Re: St. Lucie Plant Unit 2
Docket No. 50-389
Renewed Facility Operating License No. NPF-16

Response to Request for Additional Information Identified During Audit of the Non-Loss
of Coolant Accident Safety Analyses Calculations for the Extended Power Uprate
License Amendment Request

**Response to Request for Additional Information
Identified During Audit of the EPU LAR
Non-Loss of Coolant Accident Safety Analyses Calculations**

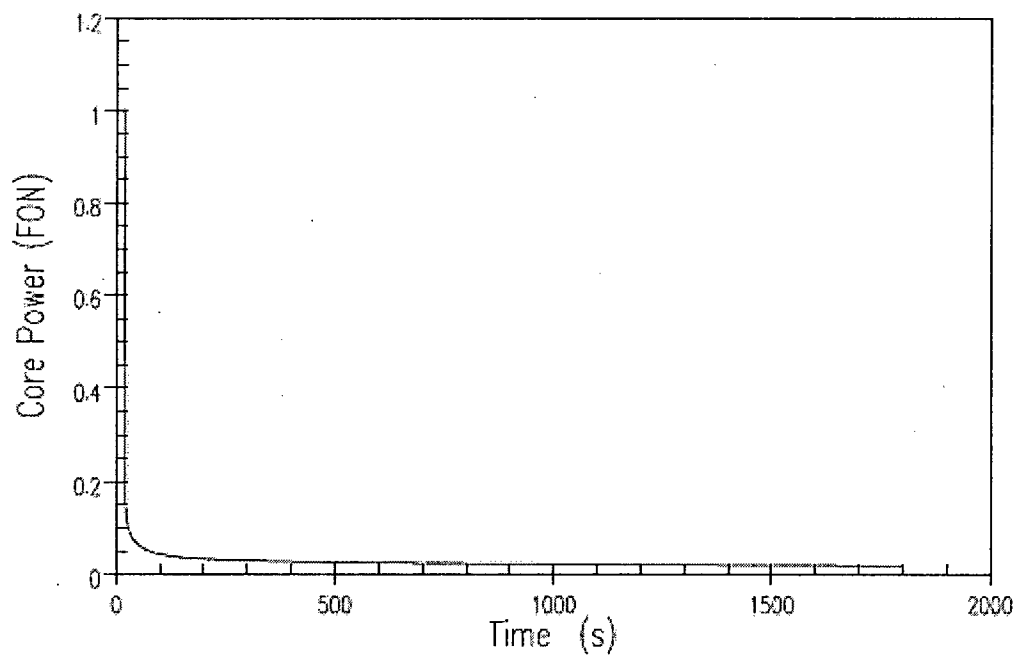
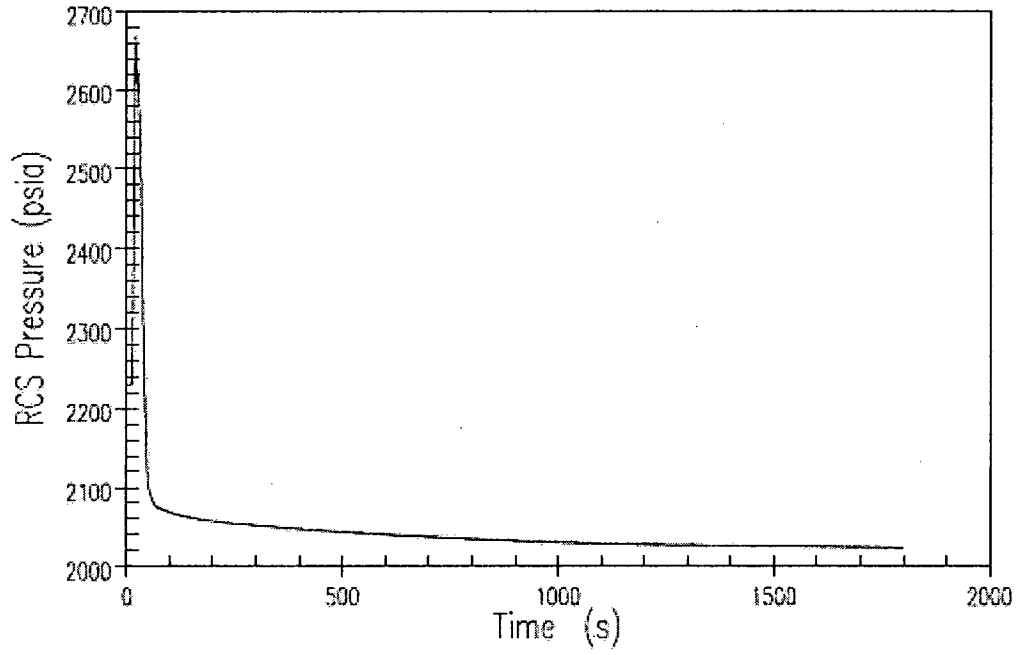
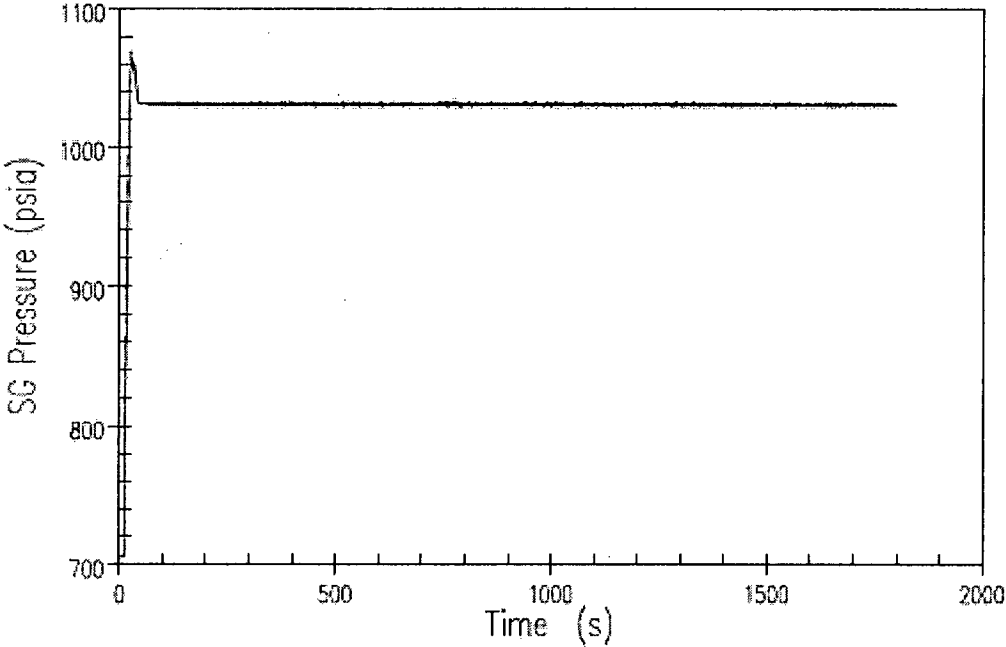
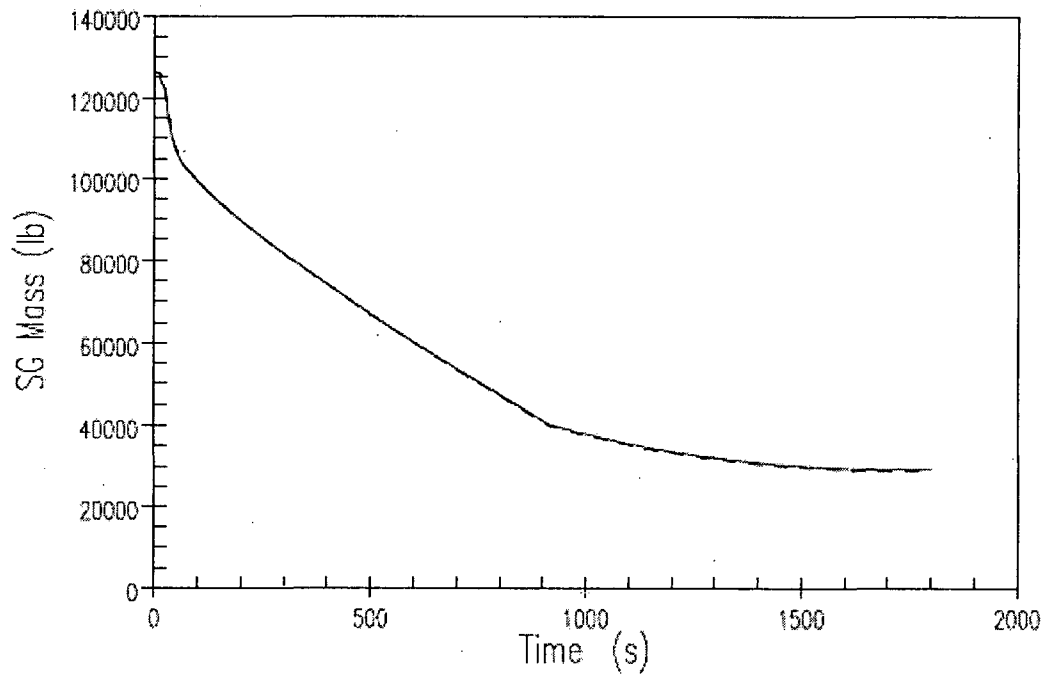
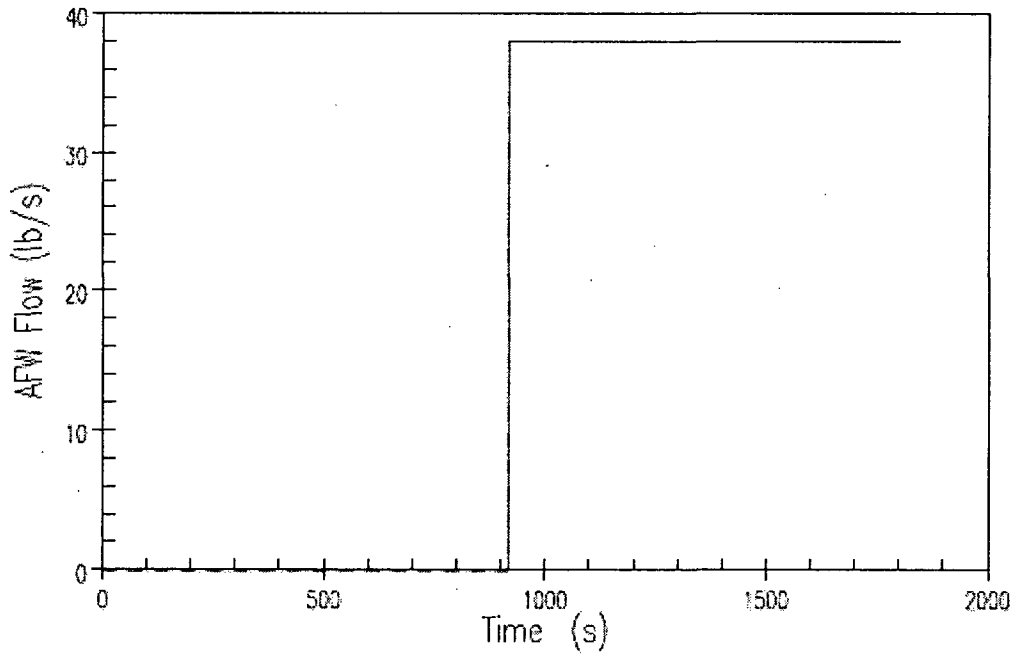
- b. **A question was asked with regard to identifying the magnitude of the second pressure peak associated with the EPU primary and secondary overpressure events for St. Lucie Unit 2. The EPU LOCV event duration captured the first pressure peak; however, the event timing did not indicate the impact of auxiliary feedwater (AFW) flow addition and the second pressure peak that could be associated with AFW initiation. Please evaluate the peak pressure event to determine the impact of the second pressure peak.**

To determine the magnitude of any second pressure peak, the LOCV event was reanalyzed by extending the end time of the event past the point of auxiliary feedwater (AFW) initiation where the second pressure peak could occur. The Section 2.8.5.2.1.2 event was reanalyzed utilizing the current licensed LOCV methodology. There is no second peak in pressure as the main steam safety valves (MSSVs) are adequately sized to provide sufficient cooling to remove the decay heat of the event.

Table LOCV-1 provides a summary of the initial conditions modeled in the LOCV event. Table LOCV-2 provides the sequence of events for the extended LOCV event and indicates that the peak primary pressure is the same as that listed in Table 2.8.5.2.1-2. Figures LOCV-1 through LOCV-5 provide additional details for the extended LOCV event.

The MSSVs demonstrated that they are adequately sized to provide sufficient cooling to offset the decay heat generated; therefore, the secondary overpressure case listed in Table 2.8.5.2.1-3 remains bounding. Therefore, the primary and secondary side peak pressures discussed in Section 2.8.5.2.1.2 remain bounding and the MSSV relief capacity is sufficient to preclude any second pressure peaks during the event.

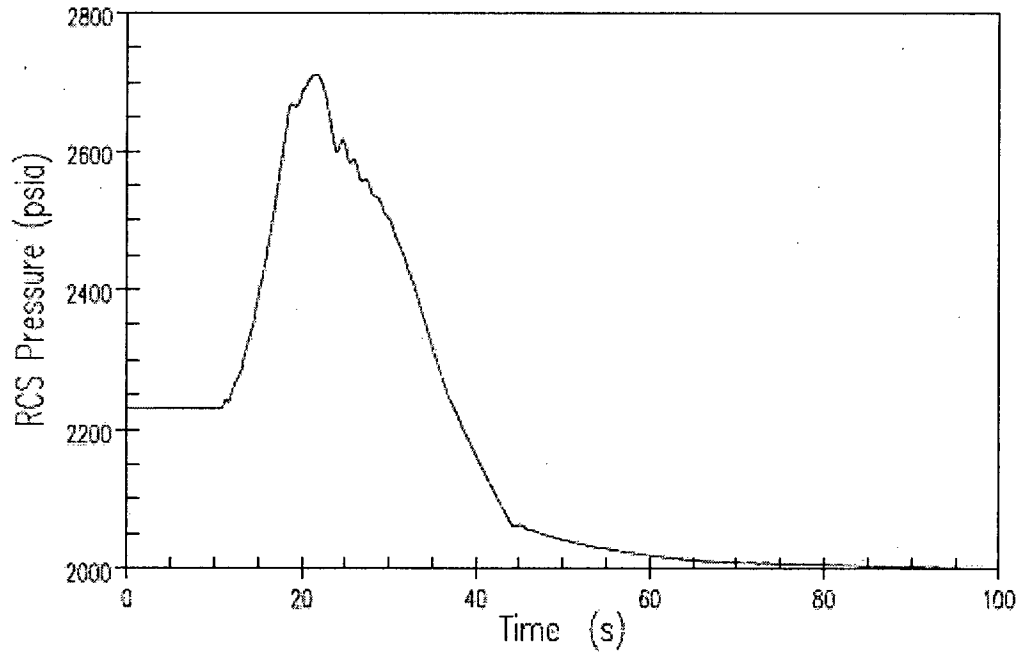
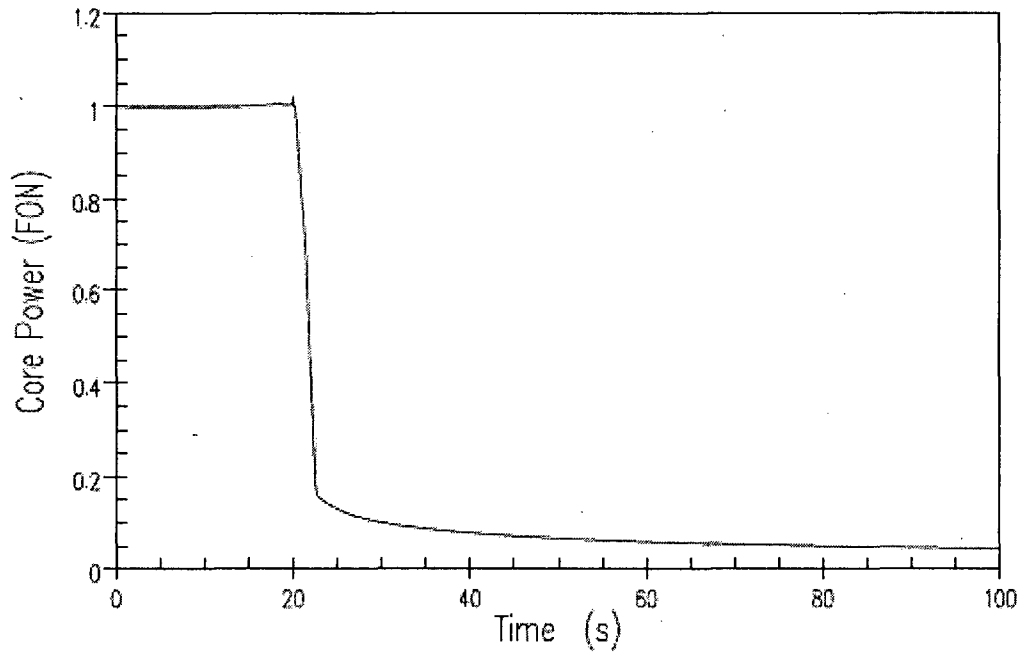
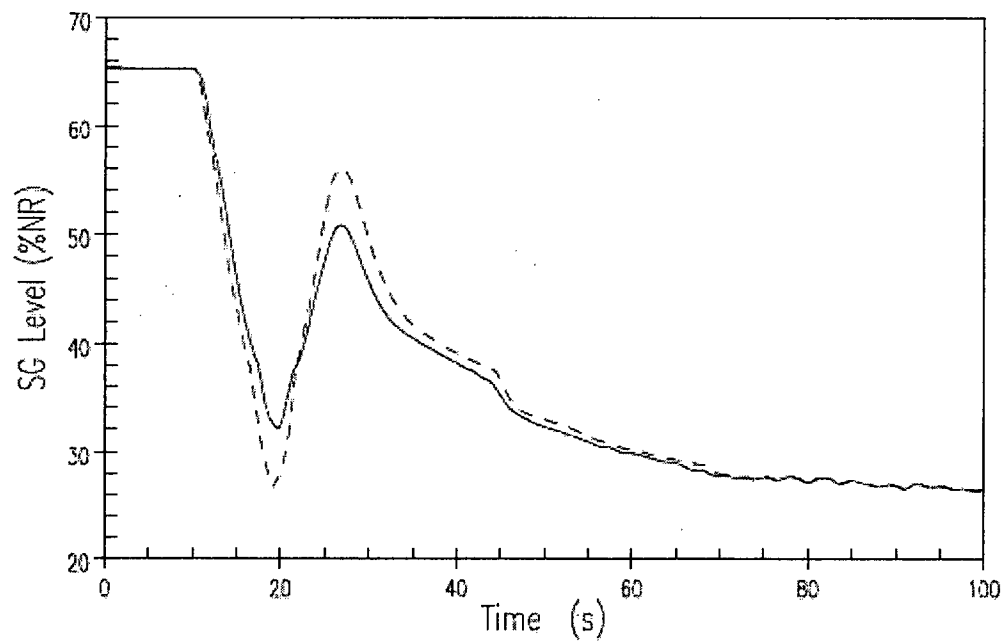
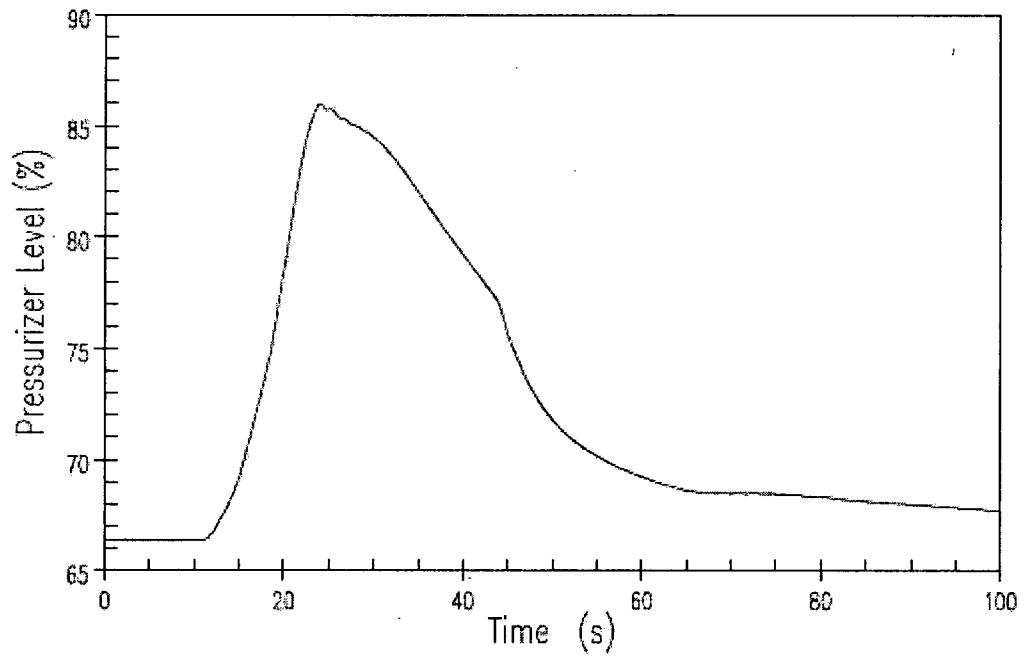
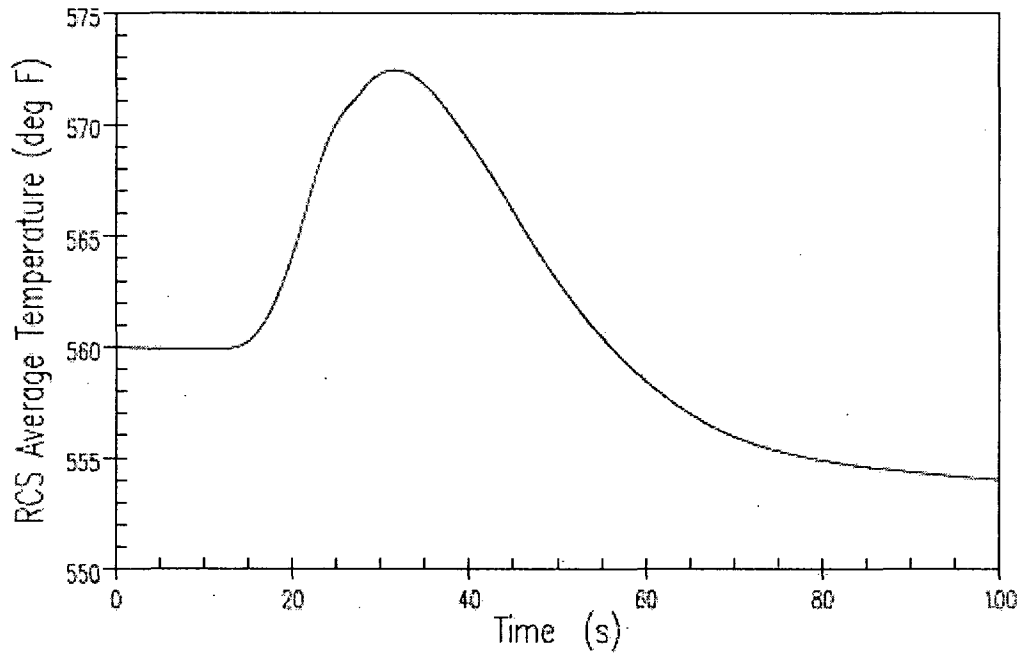
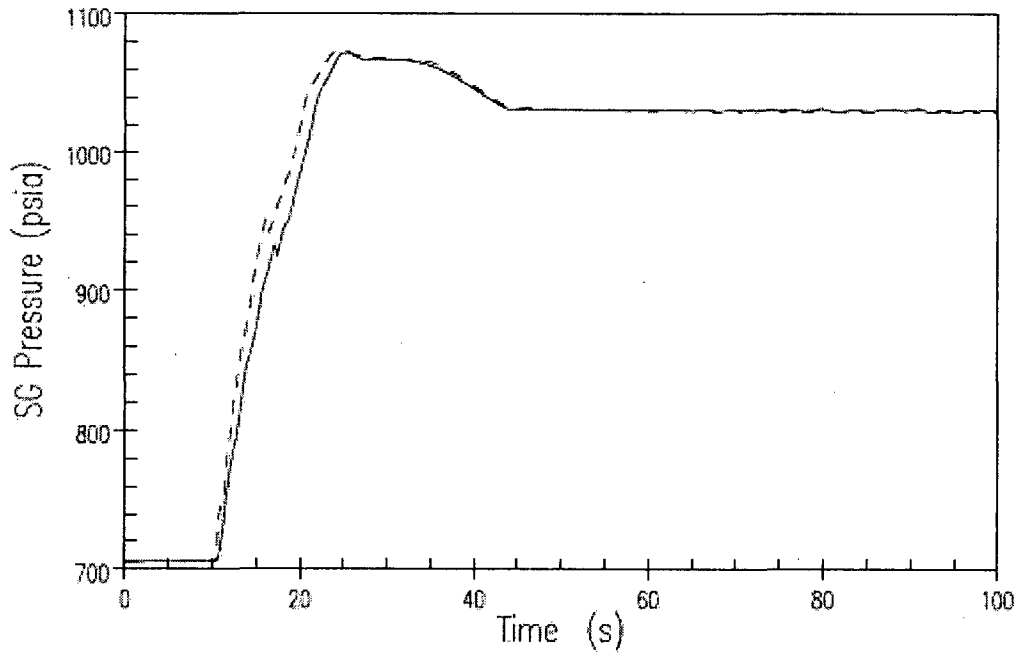
- c. **A question was asked with regard to the impact of crediting the second safety grade reactor trip function on the primary overpressure analysis. Specifically, what would the impact on peak primary pressure be if the first safety grade reactor trip was bypassed and only the second safety grade reactor trip was credited as noted in SRP Section 5.2.2?**

The event was analyzed utilizing the current licensed LOCV methodology and Table LOCV-3 provides a summary of the initial conditions modeled. The reactor trip was delayed from the first safety grade reactor trip on high pressurizer pressure until the second safety grade reactor trip signal on steam generator low level. The reactor trip setpoint credited for steam generator (SG) low level is 30% NR, which has been reduced from the nominal value to account for the SG level uncertainty. Table LOCV-4 lists peak primary overpressure for the analyzed event and demonstrates that the peak pressure of ~2712 psia remains below the acceptance criteria of 2750 psia.

Figures LOCV-6 through LOCV-11 provide additional details for the analyzed LOCV event assuming only the second safety grade reactor trip is credited.

The analyzed LOCV event based on the second reactor safety grade trip demonstrates that the peak primary overpressure criterion is met and therefore, the design and sizing of the pressurizer safety valves meets the overpressure design criterion cited in the SRP Chapter 5.2.2.

Figure FWLB-5
Pressurizer Liquid Volume vs. Time

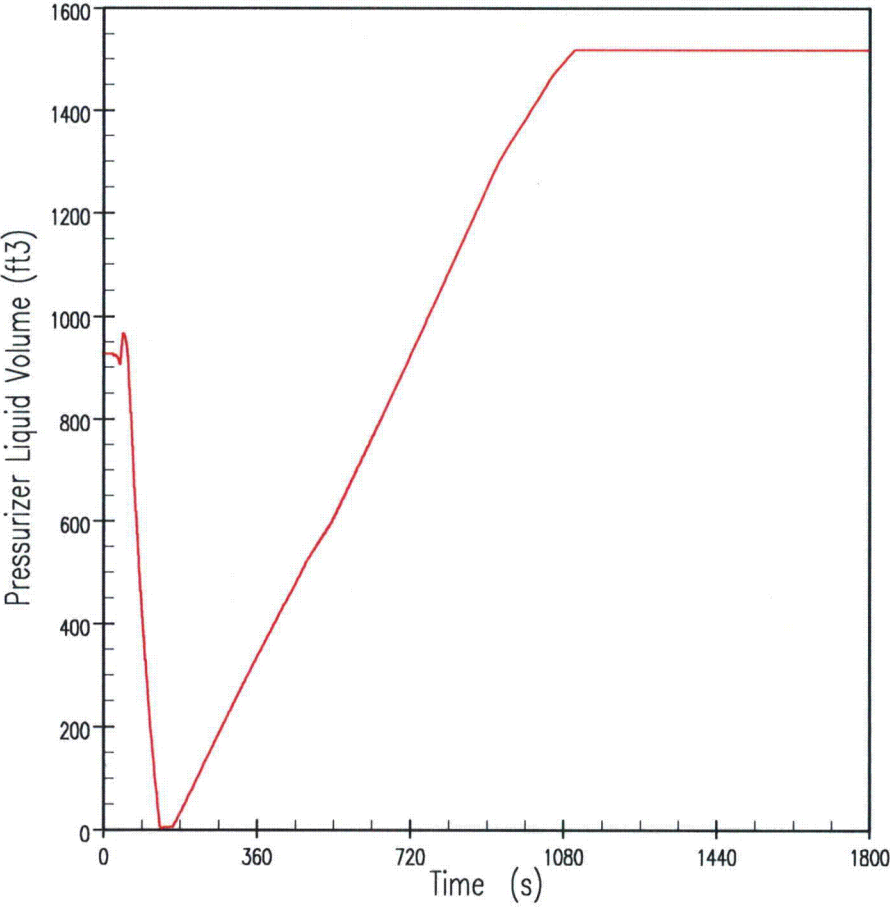
Provide the results of reanalysis of the LTC analysis for the LONF and FWLB with and without LOOP events and demonstrate compliance with the applicable acceptance criteria. The requested information should include the following:

Figure FWLB-5 shows that the pressurizer reaches the maximum volume at approximately 1100 seconds. With the PORV open at that time, there is a potential that water from the RCS may escape into containment and thereby creating a radiological release situation. However, this situation is bounded by the radiological dose calculation for FWLB presented in LAR Attachment 5, Section 2.9.2.9. The analysis presented in Section 2.9.2.9 assumes a conservative release of both SG inventories with maximum RCS leakage directly to atmosphere through an outside of containment break. Additionally, the RCS leakage is assumed to occur for a 12.4 hour period before steam release is terminated to maximize the reactivity released through the outside of containment FWLB. The LTC FWLB analysis described in this response is bounded by Section 2.9.2.9 as only the inventory from the affected SG is released to the inside of the containment via the break.
